STATE OF MAINE  
DEPARTMENT OF TRANSPORTATION  
16 STATE HOUSE STATION  
AUGUSTA, MAINE 04333-0016

March 25, 2021  
Subject: Precast Concrete Box Culvert  
WIN: PH018915.70  
Location: **Brewer**  
**Amendment No. 3**

I-395/ROUTE 9 CONNECTOR  
FELTS BROOK (55+08)  
BREWER-EDDINGTON PENOBSCOT COUNTY  
**PRECAST BOX DETAILS - FELTS BROOK BRIDGE**

**2A**

PROPOSED TRANSVERSE BOX SECTION

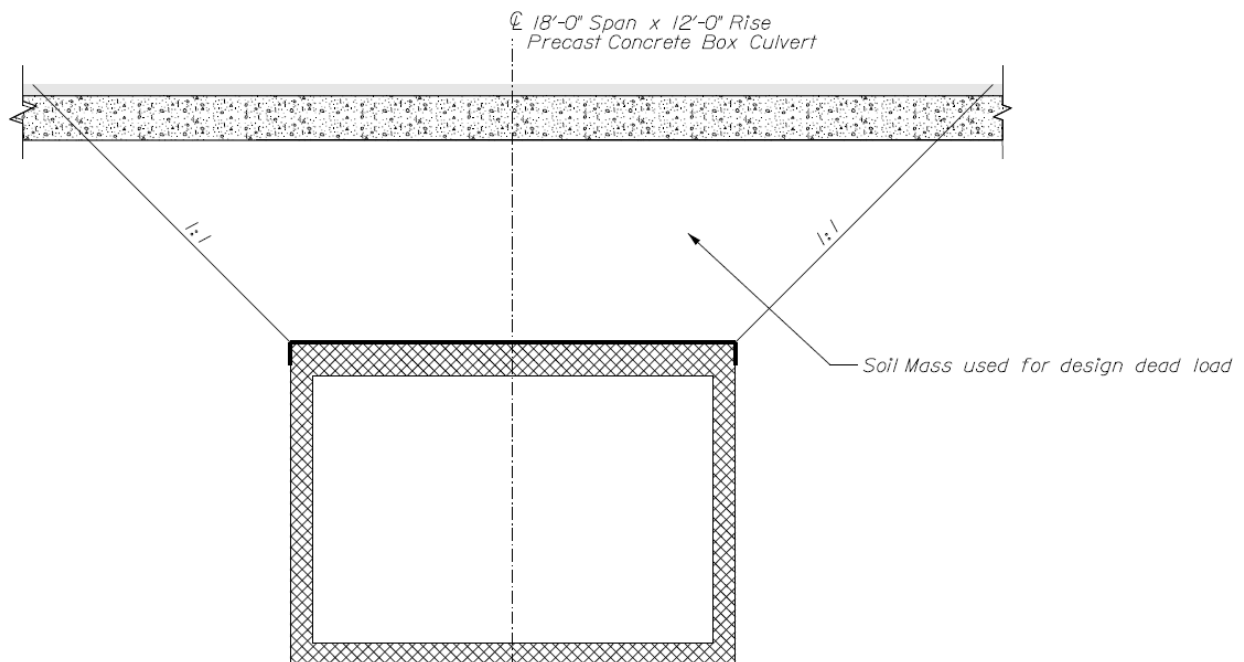
**Felts Brook Bridge #6642 will be supported by a concrete slab on steel H-piles to avoid unusually high soil settlements. To account for additional forces from approach settlement, the design dead loads for soil above the culvert shall include the weight of all the soil contained within a failure surface rising away from the top corners of the box culvert at a 1:1 slope on both sides.**

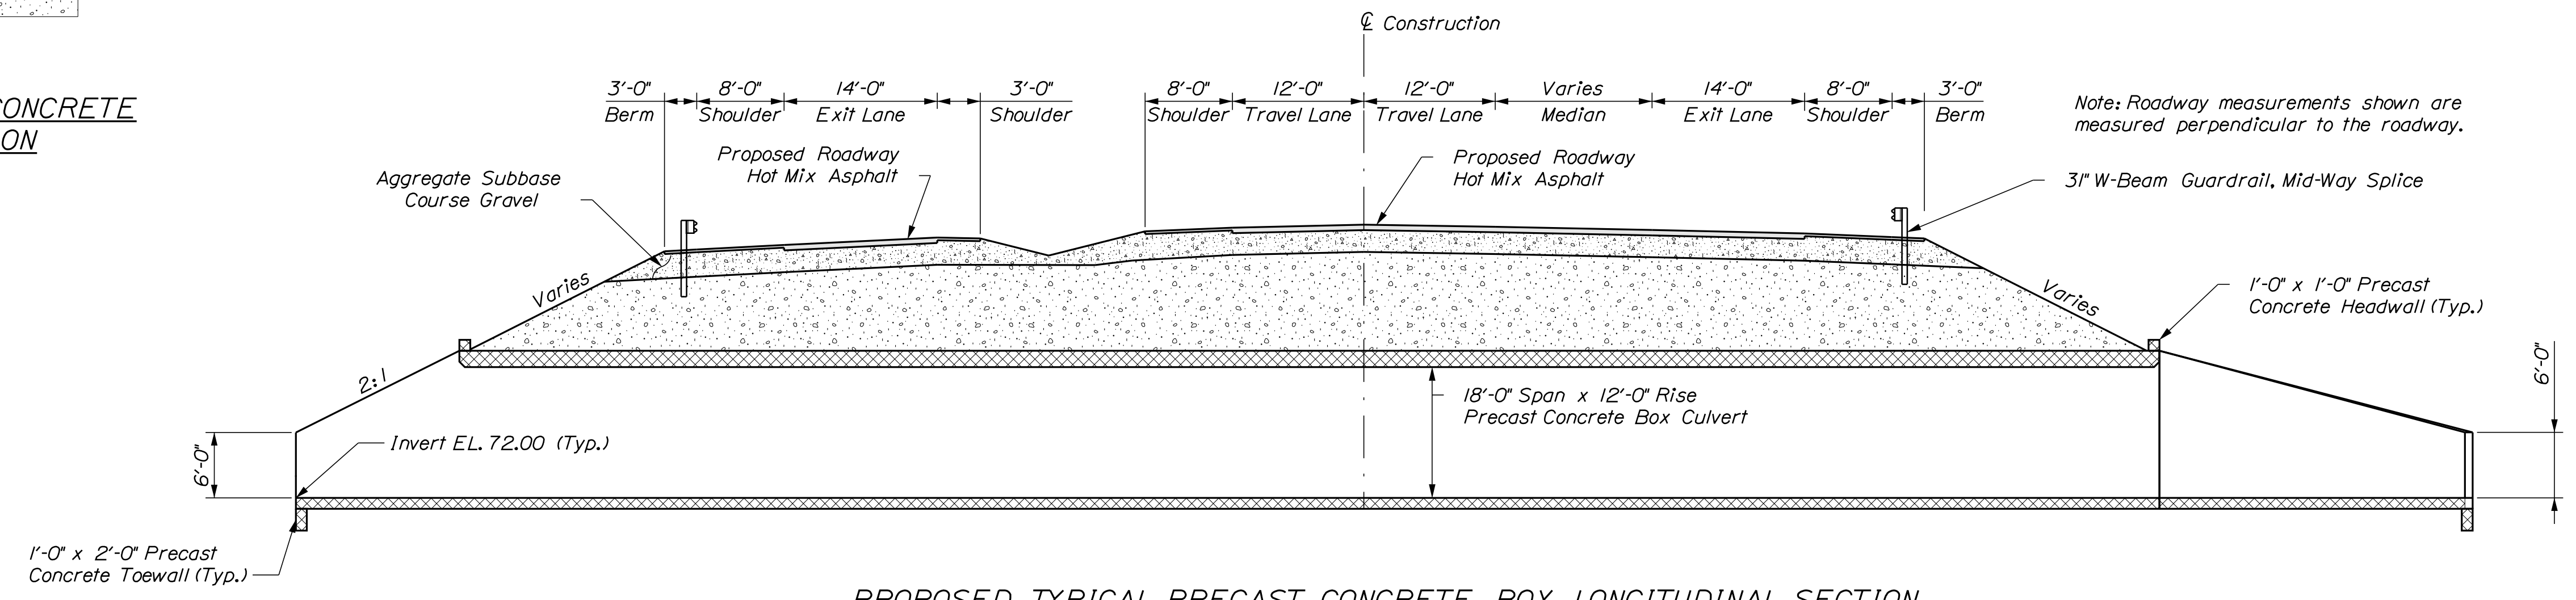
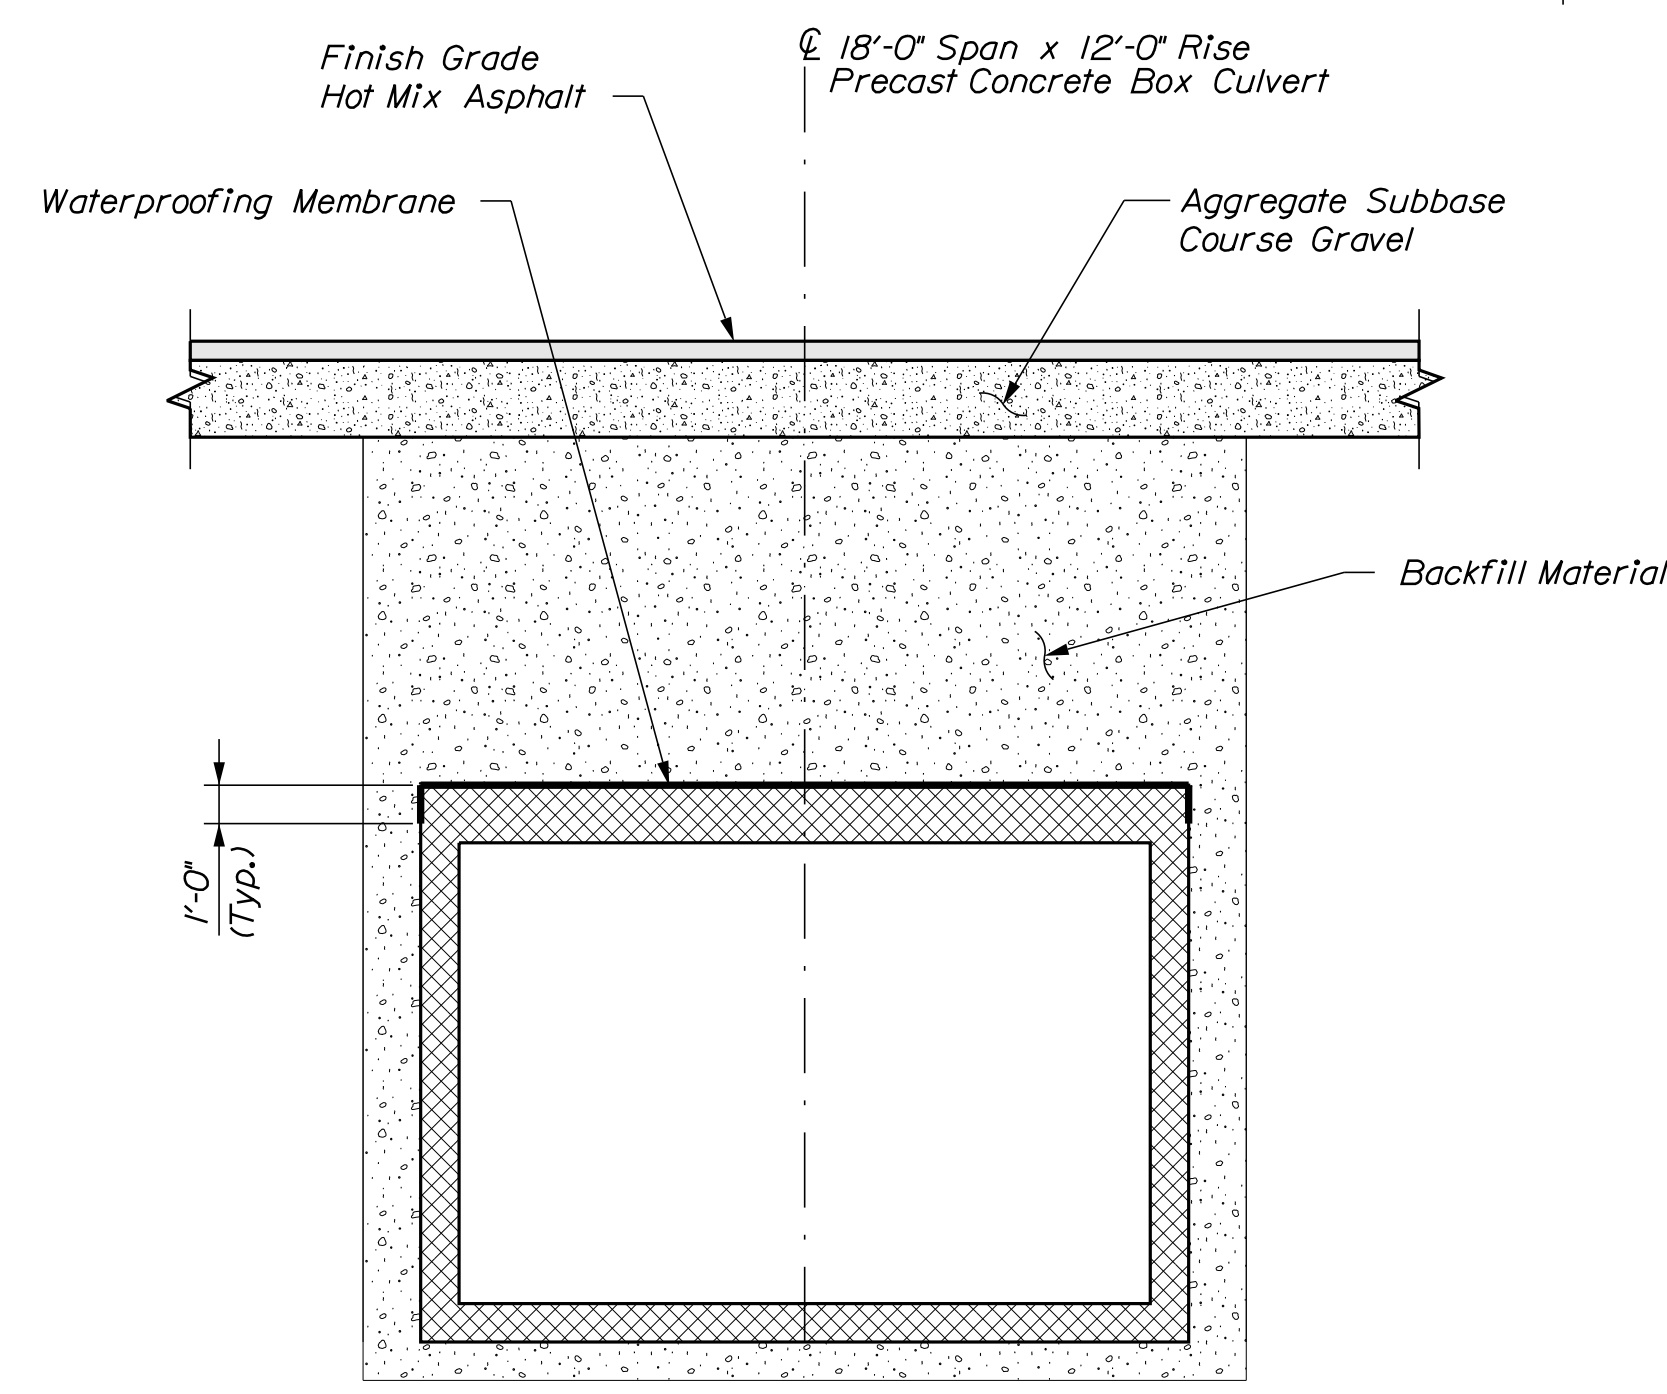
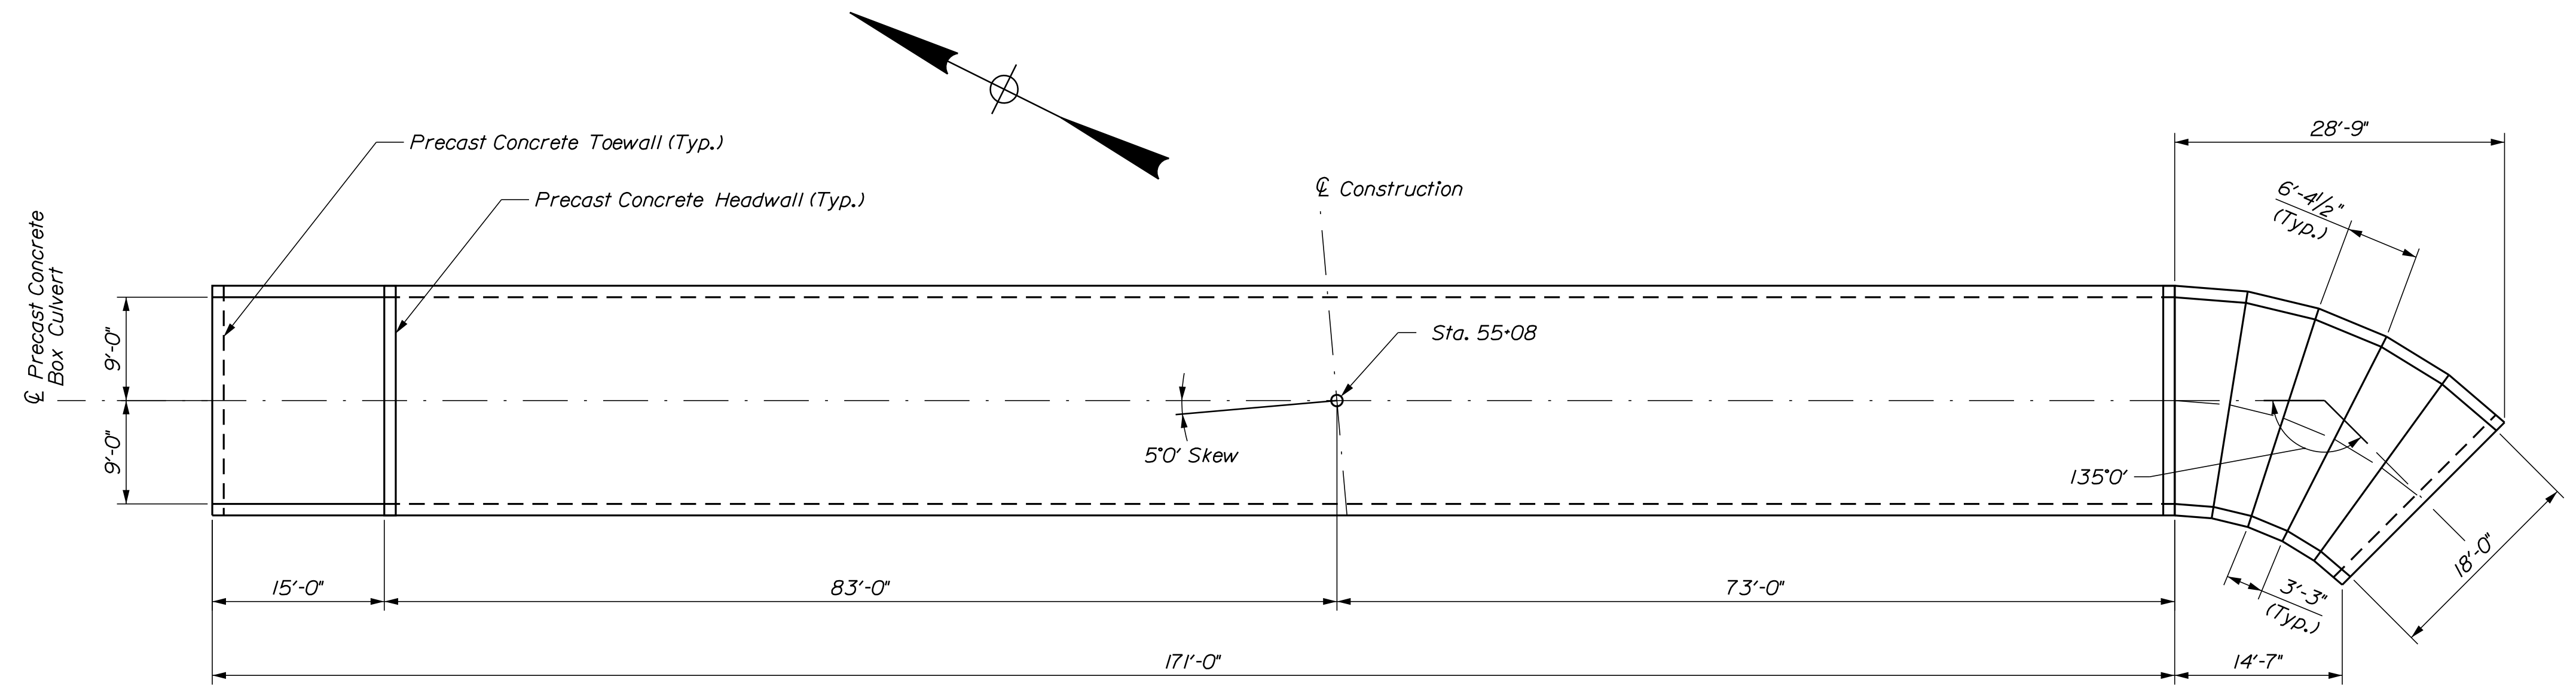
**REMOVE** Sheet 2 and **REPLACE** with Sheet 2A, revisions dated March 2021.

The revisions to both the Plan Set and Bid Book add additional soil dead load over the Felts Brook Bridge box culvert that will need to be accounted for in the design of the precast sections. See subsection 534.04 in the Special Provision (changes are in bold text) and Note 5 on Sheet 2A for the design requirements.

5. The box culvert will be installed on a gravel pad, which is supported by a concrete slab on steel H-piles to avoid unusually high soil settlements. To account for additional forces from approach settlement, the design dead loads for soil above the culvert shall include the weight of all the soil contained within a failure surface rising away from the top corners of the box culvert at a 1:1 slope on both sides.
